NATIONAL TRANSPORTATION SAFETY BOARD  
Office of Research and Engineering  
Washington, DC  
July 25, 2005

**ADDENDUM 1 TO THE AIRCRAFT PERFORMANCE STUDY AND  
CVR OVERLAY**

**DCA05MA004**

Aircraft: British Aerospace Jetstream 32, N87JX

Figure1S. Altitude Profile with CVR Overlay

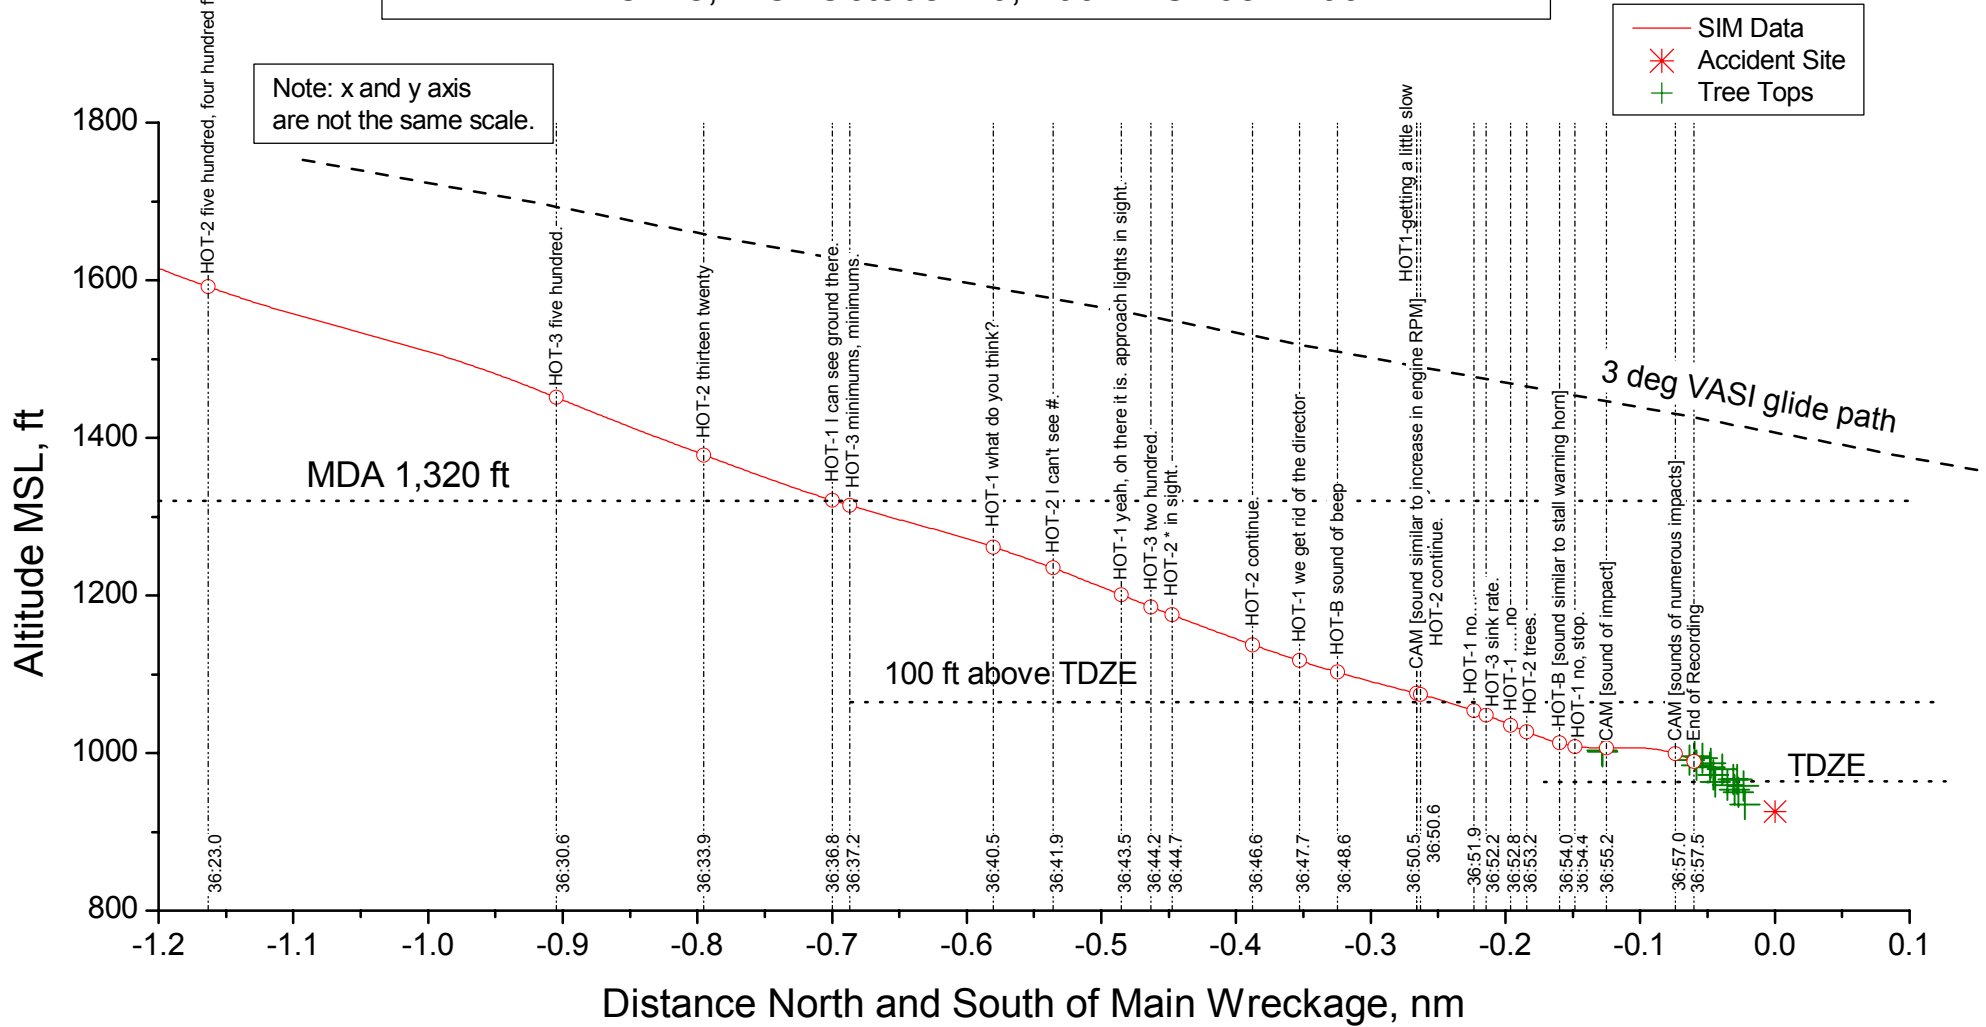
- The two CVR transcript items listed below were added to figures 1S, 2S and 3S.

1936:47.7

**HOT-1** we get rid of the director.

1936:48.6

**HOT-B** [sound of beep]

- The time of the CVR transcript item listed below was changed to 1936:40.5 as a result of CVR Group Chairman's Factual Report Errata<sup>2</sup>.

1936:35.7

**HOT-1** what do you think?

- The word "Excerpt" was added to the title of figure 1S.
- A line was added to figure 1S to depict the runway touchdown zone elevation.
- A label to identify the trees in figure 2S was added.
